ENGINEER'S SEAL	1409 CHELWOOD	DRAWN BY WCMJ
DAVID SOULE NEW MEXICO 14992 P.E. #14522	GRADING AND DRAINAGE PLAN	DATE 12-27-11
		21144-LAYOUT-12-27-11
		SHEET #
		JOB # 21144

I David Soule, NMPE 14522, of the firm Rio Grande Engineering, hereby certify that this project has been graded and will drain in substantial compliance with and in accordance with the design intend of the approved plan dated 1/16/12. The record information edited on the original design document has performed by me or under my direct supervision and is true and correct to the best of my knowledge and belief. The as-built survey was provided by David Vigil NMPS 8911. The certification is submitted in support of a request for Certificate of Occupancy. The record information presented heron is not necessarily complete and intended only to verify substantial compliance of the grading and drainage aspects of this project. Those relying on this record document are advised to obtain independent verification of its accuracy before using it for any other purpose.

ENGINEER'S SEAL	1409 CHELWOOD	DRAWN BY WCUJ
	GRADING AND DRAINAGE PLAN	DATE 12-27-11
		21144-LAYOUT-12-27-11
		SHEET #
		JOB # 21144

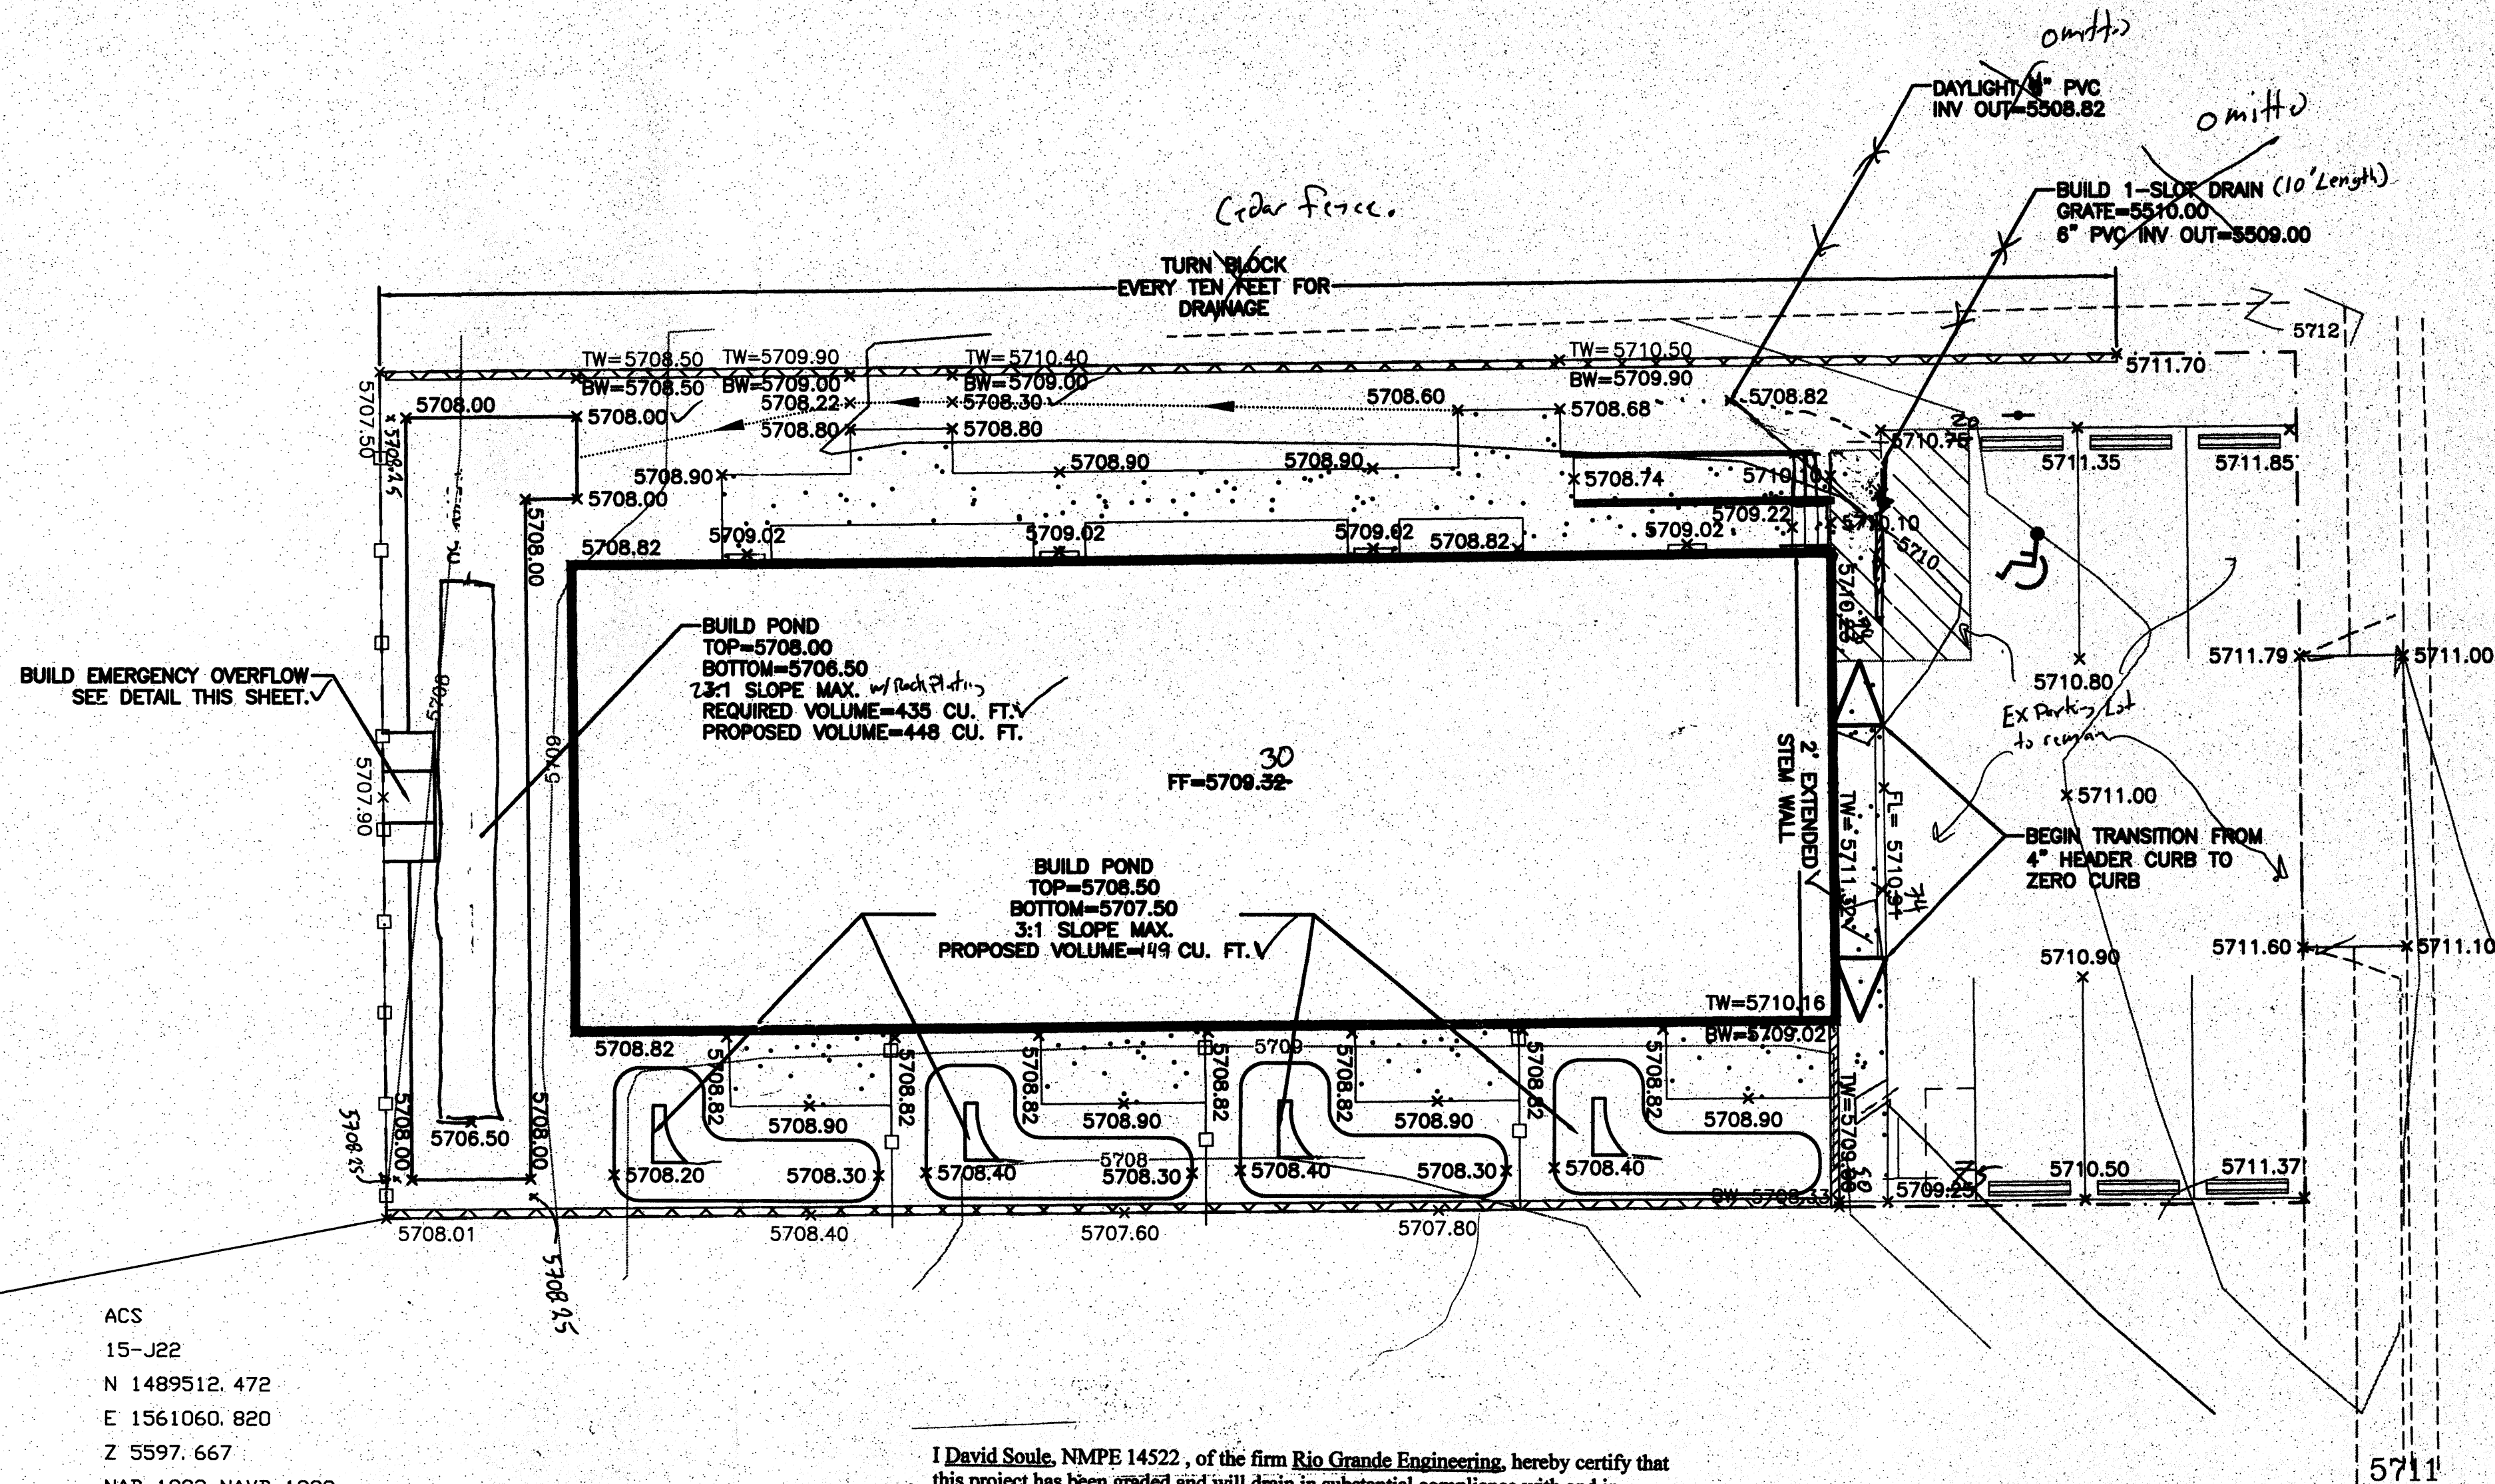
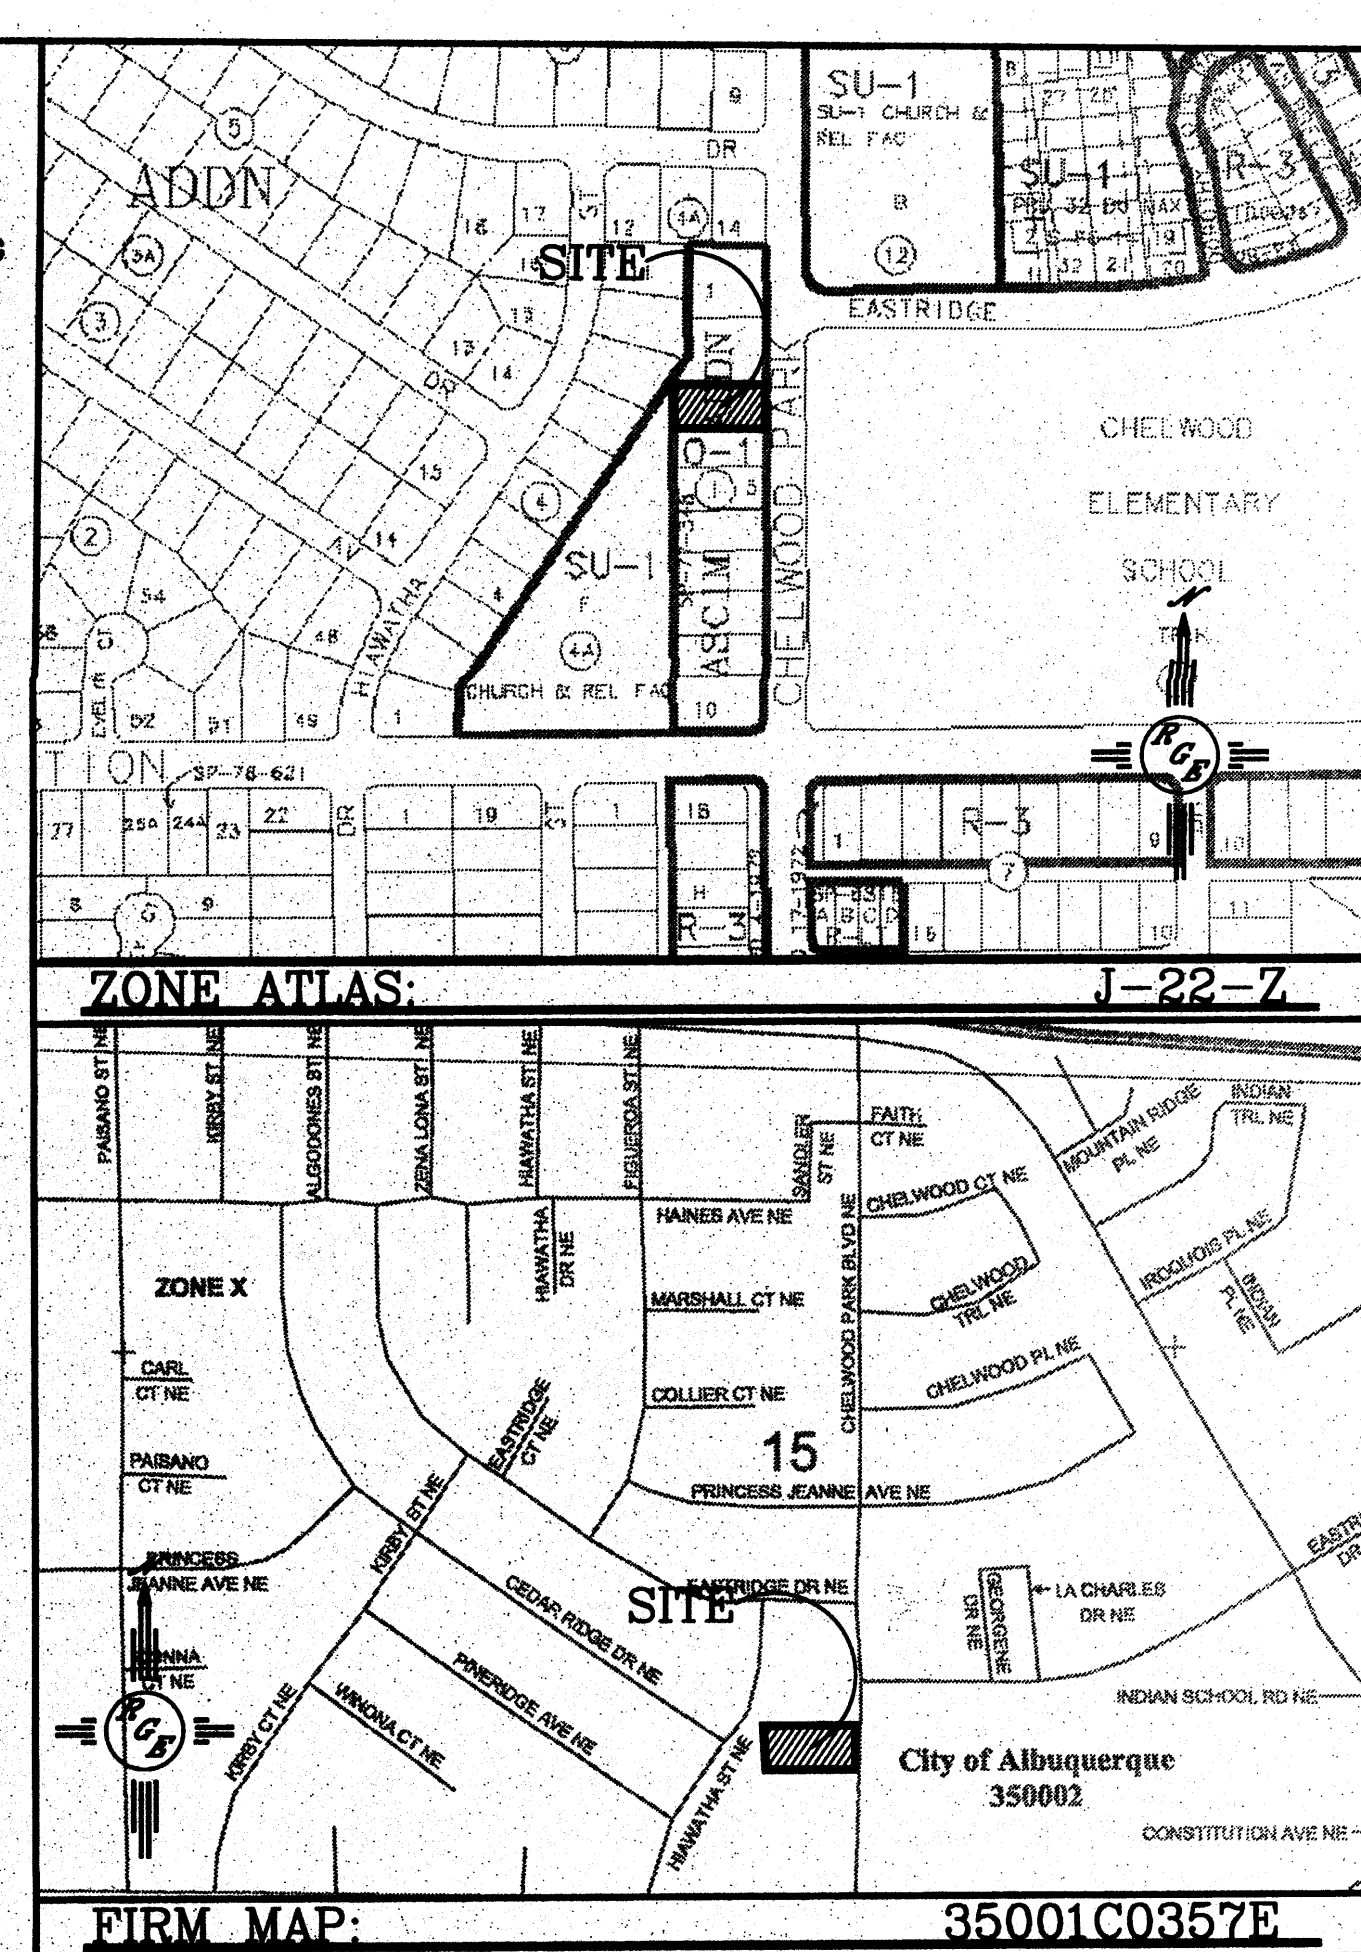
Exception

1. Parking lot was removed due to condition of asphalt, and replaced with concrete. The existing drainage pattern was maintained. This allowed the northwest corner of parking lot to be lowered, to allow for surface drainage, and the slot drain was omitted.
2. Pond side slopes increased, required volume provided
